Subject: Structural Engineering Report – Floor loading evaluation – golf club,
Black Mountain, NC
Project Number: 209210

Project No: 209210
 Sheet No.: SK-1
 1 OF 1
 FLOOR LOADING EVALUATION
 GOLF CLUB
 BLACK MOUNTAIN
 NORTH CAROLINA
 Drawing Title:
REFERENCE PLAN

**BLACK MOUNTAIN GOLF CLUB (MULTI-USE BUILDING)
ON-SITE FIELD EVALUATION**

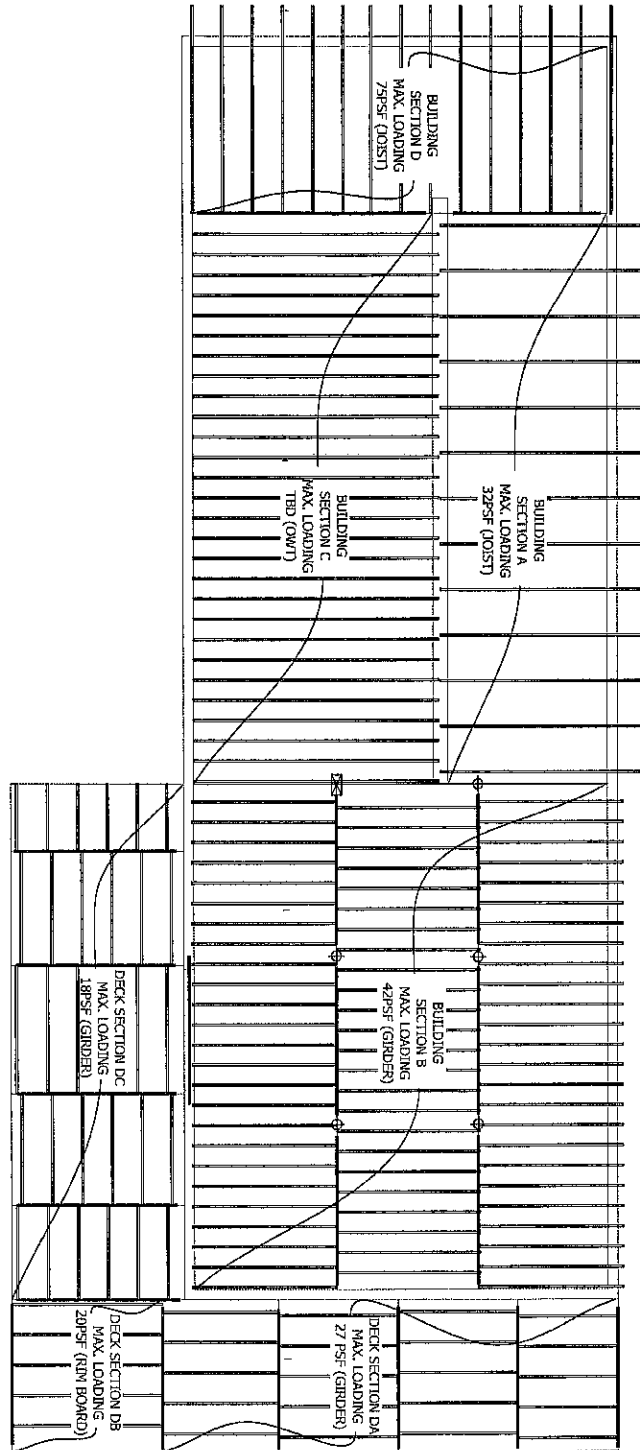
- The remainder of the main level interior floor framing systems vary in live load capacity from 32 PSF to 75 PSF. See the attached drawing for loading information and locations.

Snack Shop: The floor system is not adequate for NCSBC required loading (100psf). Additional posts, beams, floor joists, concrete footings will need to be added to reach the requirements.

Men's Club: The floor system is not adequate for NCSBC required loading (100psf). The floor joists are adequate to carry the load however the beams are not. Adding concrete footings, with a post under each beam between existing posts will take care of the problem.

Deck: The existing deck presents a serious safety issue, with load capacity varying between 18 & 27psf. The deck should not be used at all until the condition is remedied. To reach required load bearing capacity (100psf), concrete footings and 2 posts will need to be added under each existing beam and a joist added between each existing pair of joists. This deck fails to meet even residential loading capacity (40psf). Recommend removal of furnishings, locking or boarding up access points, and posting notice of danger condition.

Women's Club: The floor system (concrete slab on grade) is adequate for NCSBC required loading (100psf).
